Dante CS Build ME Solution

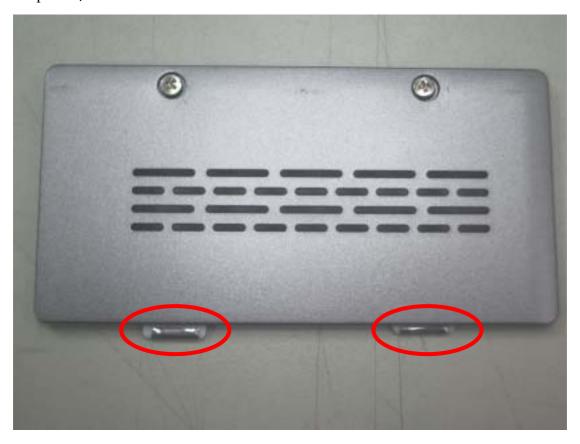
—. Red circle from A case aluminum foil arrive camera position , is shown as diagram.

the panel post top gasket must with A case the aluminum foil conduct electricity fluent.

this for camera the EMI solution.

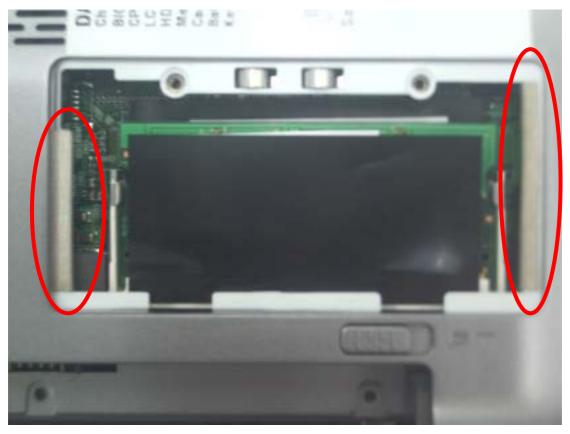
☐. RAM door use aluminum foil shielding and connect to the below shell.

the photo , RAM door two sides must be anti- to fold with below hull.

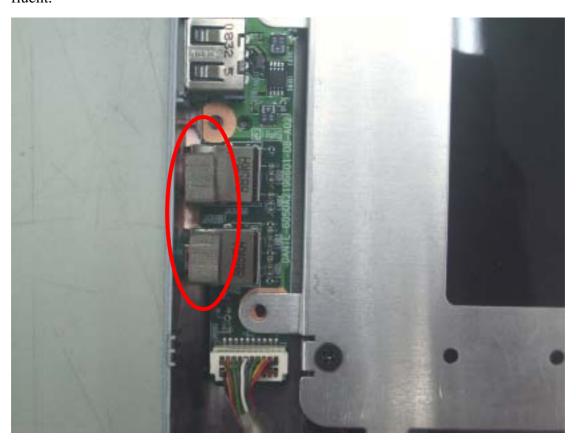
below hull use conduct electricity cloth and RAM door connect and conduct electricity fluent.
